# UNITED STATES PATENT AND TRADEMARK OFFICE

APPLICATION NO.	FILING DATE	FIRST NAMED INVENTOR	ATTORNEY DOCKET NO.	CONFIRMATION NO.
10/520,579	10/03/2005	Peter D Hood	17638-005US1	5951
26161 7590 04/12/2010 FISH & RICHARDSON PC P.O. BOX 1022 MINNEAPOLIS, MN 55440-1022				
EXAMINER WANG, EUGENIA				
ART UNIT 1795		PAPER NUMBER		
NOTIFICATION DATE 04/12/2010		DELIVERY MODE ELECTRONIC

### Office Action Summary

**DETAILED ACTION**

FIG. 3

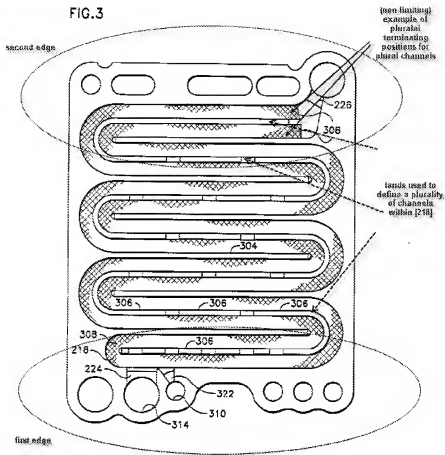
Furthermore, there is a distribution foil (cooler-humidifier plate [202]) wherein with a plurality of channels (fig. 3). (It is noted that the lands [304] and island lands [306] are taken to from a plurality of channels within channel [218]. Additionally, it is noted that although not depicted, that one embodiment includes a plurality of channels (col. 7,

lines 59-63). As seen in fig. 2C, portions of the channel of cooler-humidifier plate [202] extends across the plate. "At a first edge" (see 112 rejection for interpretation as to what constitutes "at") can be interpreted to be the inlet portions, such as inlet manifold hole [314] and water inlet hole [310] as well as upper portions of the channel [218] (see fig. 3). "At a second edge" (see 112 rejection for interpretation as to what constitutes "at") can be interpreted to be the outlet portions, such as gas outlet [226] and lower portions of channel [218] (see fig. 3). Accordingly, the channels can be said to terminate at different positions (as indicated by the wicks and lands of fig. 3), wherein it can be seen in fig. 2C that the channels of the cooler-humidifier plate [202] are coincident with those of the cathode flow plate [216]. It is noted that outlet [226] bridges the termination of the channels (end portion of channel [218]) as well as provides direct fluid communication with a respective field plate channel (as it provides cathode gas water via manifold [256]) (fig. 2C; col. 7, lines 20-31). This constitutes a water injection point that enables delivery of water directly into corresponding field plate channel. The embodied material for the cooler-humidifier plate [202] is stainless steel (thus qualifying it to be considered a foil) (col. 6; lines 33-35). See annotated figure below for clarification as to the interpretation taken with respect to the distribution foil (cooler-humidifier plate [202]).

It is noted that the cathode plate [216] is seen to be a cover extending over the distribution foil (humidifier plate [202] to enclose the channels and form conduits for water between the them, as Vitale et al. teach that plate [216] serves the purpose of closing open-face flow channels [218] of the cooler-humidifier plate [202], wherein the wick of the coolant-humidifier plate [202] provides water to the reactant gas (col. 6, lines 44-46; col. 7, lines 64-65; fig. 3).

As to claim 3, Vitale et al. teach that the channels (portion of channel [218] close to outlet [226]) terminates at a second edge. (See annotated figure in the rejection to claim 1 as to the interpretation taken. See also the 112 section as the interpretation taken with respect to the first and second edge in light of the 112 issues.) As seen in fig. 2C, outlet [226] can be seen to be a convergence structure, as it focuses water flow into the channels [210] in the fluid flow plate of fluid flow (as humid air exits through outlet [226]) (col. 7, lines 26-30).

As to claim 4, Vitale et al.'s convergence structure (gas outlet [226]) shows a recess on the second edge of the distribution foil (plate [202]), as gas outlet [226] is cut out (fig. 3).

Examiner respectfully disagrees. It is noted that there are different "terminating" points of Vitale et al. (as defined by the lands set forth within channel [218]), wherein a place of convergence ([226]) is provided afterwards. (See annotated fig. in claim 3 in the rejection to claim 1 for details as to the interpretation taken.) It is noted that there is nothing within the claim barring such a claim interpretation. Furthermore, such a claim interpretation is made in light of the numerous 112 issues set forth above. Office personnel are to give claims their broadest reasonable interpretation in light of the supporting disclosure. *In re Morris*, 127 F.3d 1048, 1054-55, 44 USPQ2d 1023, 1027-28 (Fed. Cir. 1997). Also, limitations appearing in the specification but not recited in the claim are not read into the claim. See *In re Zletz*, 893F.2d 319, 321-22, 13 USPQ2d, 1320, 1322 (Fed. Cir. 1989). In such a manner, direct fluid communication (as claimed) is still achieved (through [226]). Additionally, it is noted that Jones et al. has also been relied upon to render obvious the teaching of a plurality of water injection points (due to the fact that Vitale et al. does only have one injection point [226]). (See rejection to claim 1 for full details.) Accordingly, it is submitted that the claimed features are
